Meeting of the Central Valley Flood Protection Board

Staff Report

Union Pacific Railroad Company

Yankee Slough Bridge 165.89 Replacement, Sutter County

PROPOSED BRIDGE – UPSTREAM FACE PROFILE

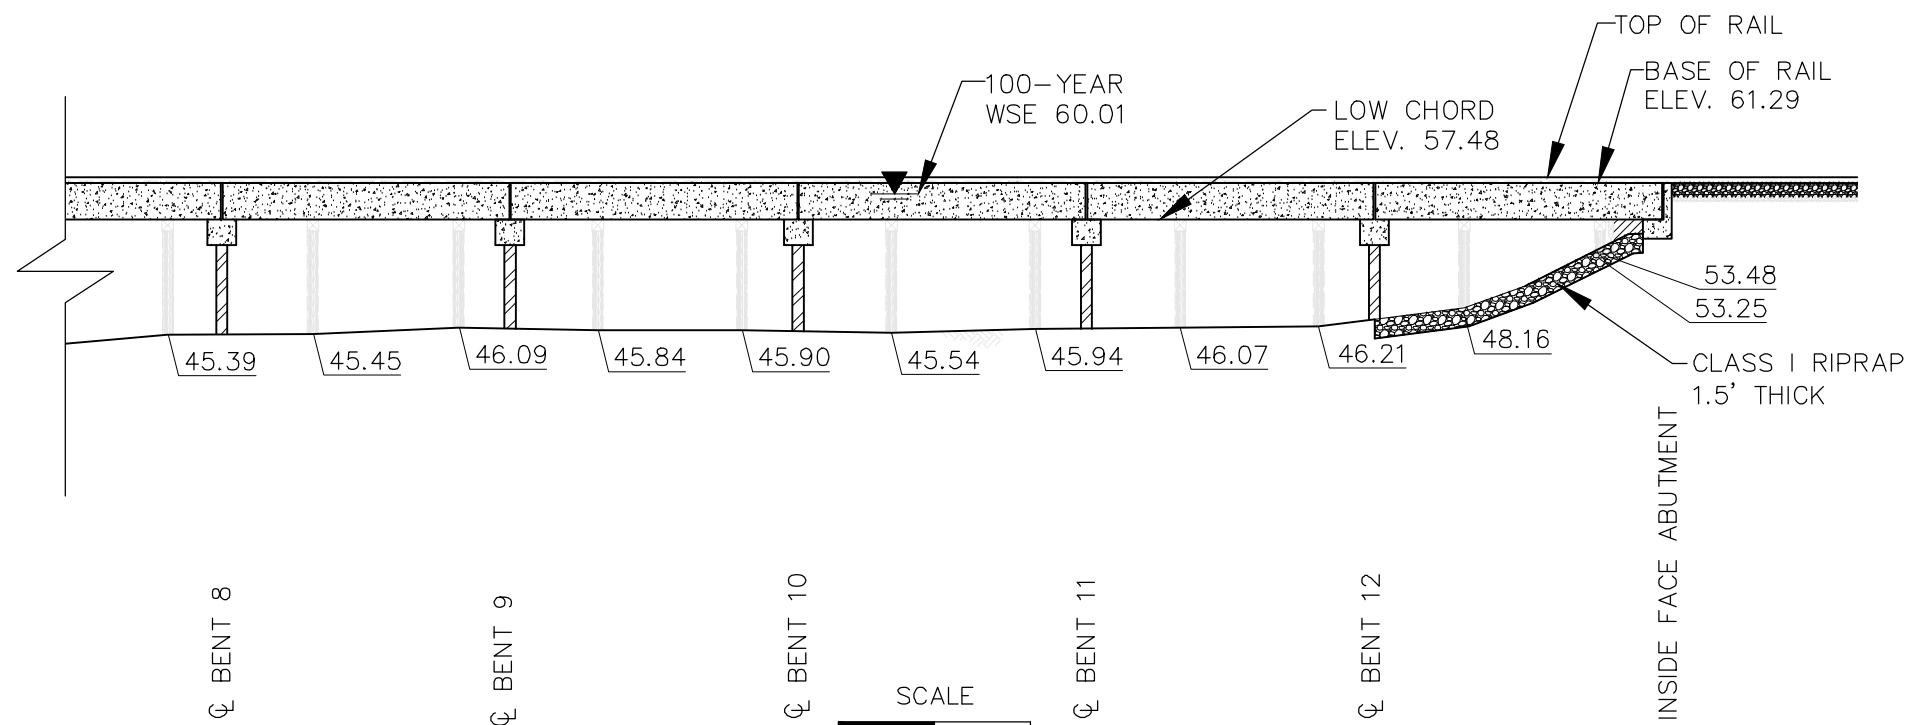
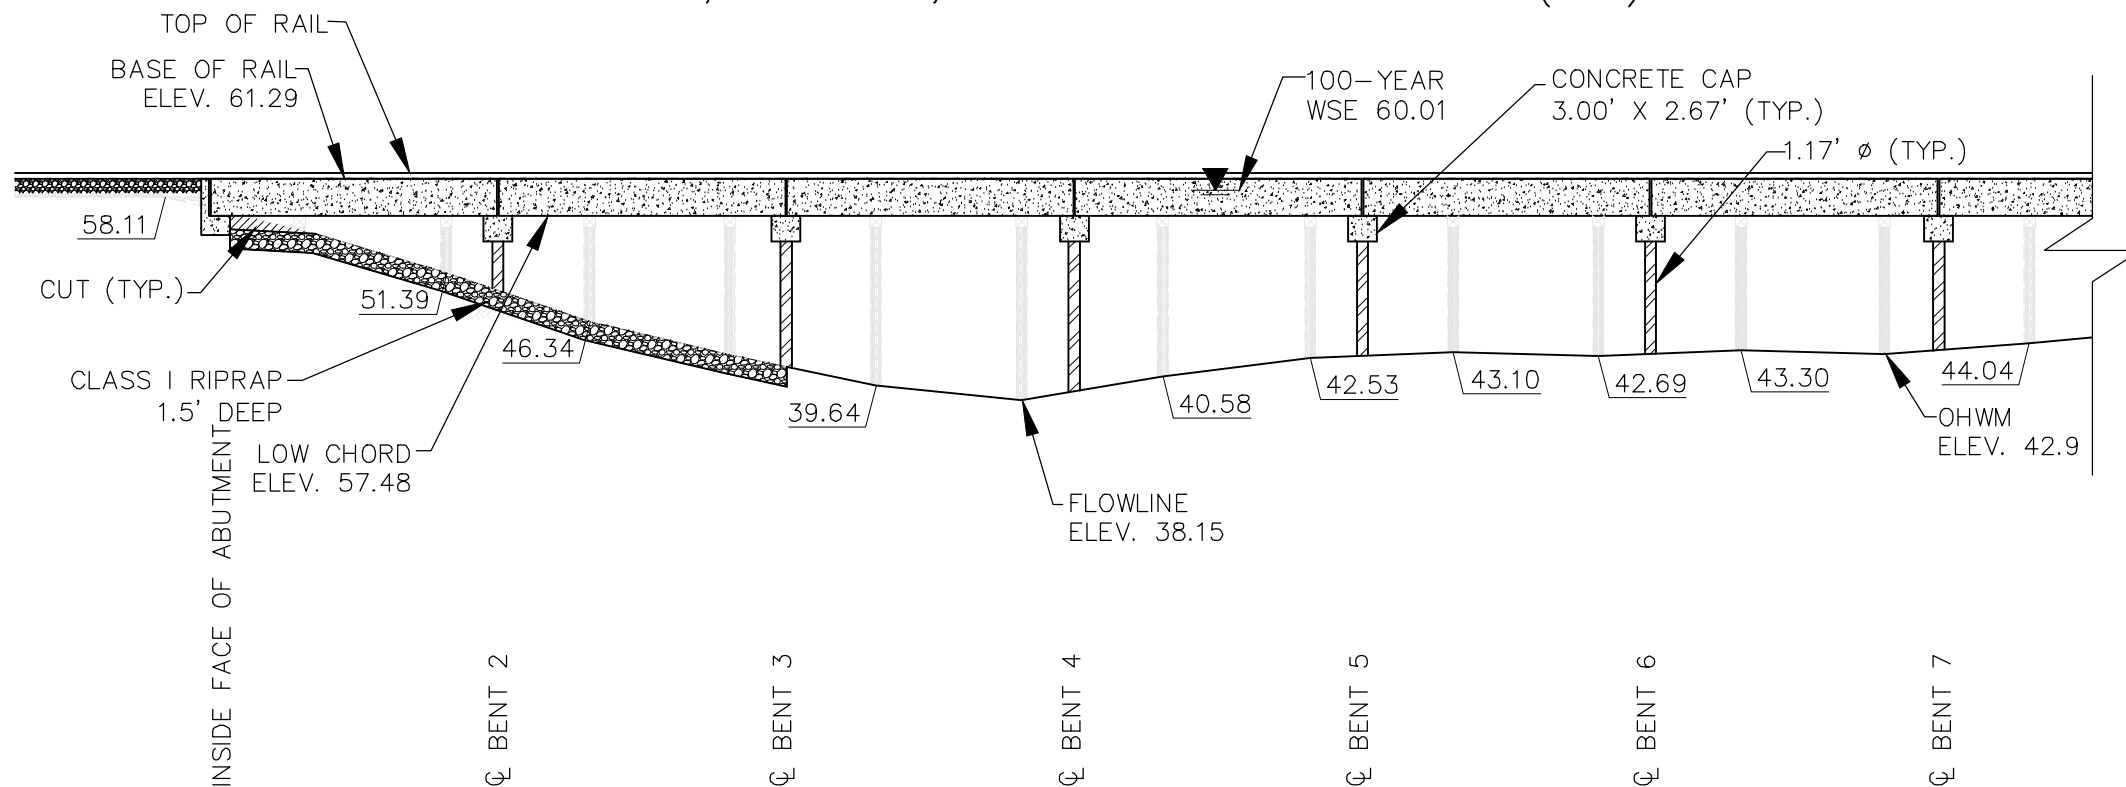
- On February 20, 2014 UPRR submitted a redesigned project after considering the concerns of nearby landowners (Attachment E). The redesign raised the track seven inches in elevation so that the proposed low chord elevation would match that of the existing bridge (no decrease of low chord) to be compliant with Title 23, § 128(a)(16). This redesign also addresses a comment from the USACE District to include rip rap along the bridge's sloping abutments. The track raise also required an additional 1,000 feet of railroad reconstruction in both directions from the bridge as UPRR as determined by UPRR to be the maximum possible raise due to nearby infrastructure and grade constraints. This redesign was also submitted to RD 1001's District Engineer.

Based on feedback from the adjacent landowners, UPRR has proposed to update the bridge construction plans to include a 7-inch track raise to match the existing bridge low chord elevation. The 7-inch track raise is the maximum raise possible at this location due to the nearby infrastructure and grade restraints. The proposed 7-inch track raise requires raising the existing timber bridge and impacts to the existing track for 1,000 ft in both direction of the bridge, substantially increasing the complexity and cost of the bridge replacement project. Per the recommendation of the U.S. Army Corps of Engineers, riprap will be placed within UPRR right-of-way along the sloping abutments of the bridge, to armor the track embankment during peak flood events.

In summary, the proposed concrete bridge's low chord elevation will be equal to the existing timber bridge low chord which results in a 3% increase in the opening area of the proposed bridge due to fewer bents within the bridge opening. The proposed bridge meets the regulatory no-rise requirement during the 100-year event (i.e. bank full capacity). If you have any questions concerning this project, or need additional information, please contact me at 402.458.5015 or bstrahm@olssonassociates.com, at your earliest convenience. Please refer your future correspondence to **Bridge 165.89, Sacramento Subdivision**.
